Float / Ski Model
2100, 2350, 3000 & 3450 Amphibious Floats

SERVICE LETTER #48

TITLE: Addition of Hydraulic Accumulator

TYPICAL INSTALLATION OF ACCUMULATOR HOSE – ALL MODELS

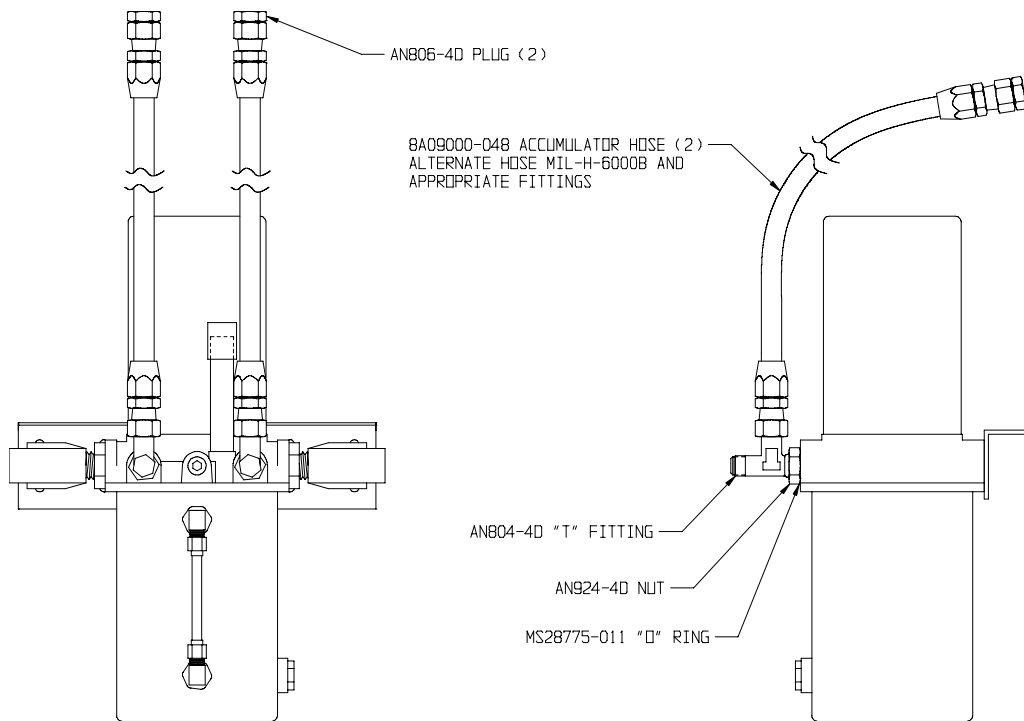
REASON: Aircraft experiencing "hydraulic lockup" (gear does not cycle up unless emergency gear selector handle is cycled) as evidenced by landing gear not retracting due to pressure buildup on back side of piston thereby not allowing opposite pressure switch to make contact.

METHOD OF COMPLIANCE: Add accumulators per Service Kit #32 and below illustrations.
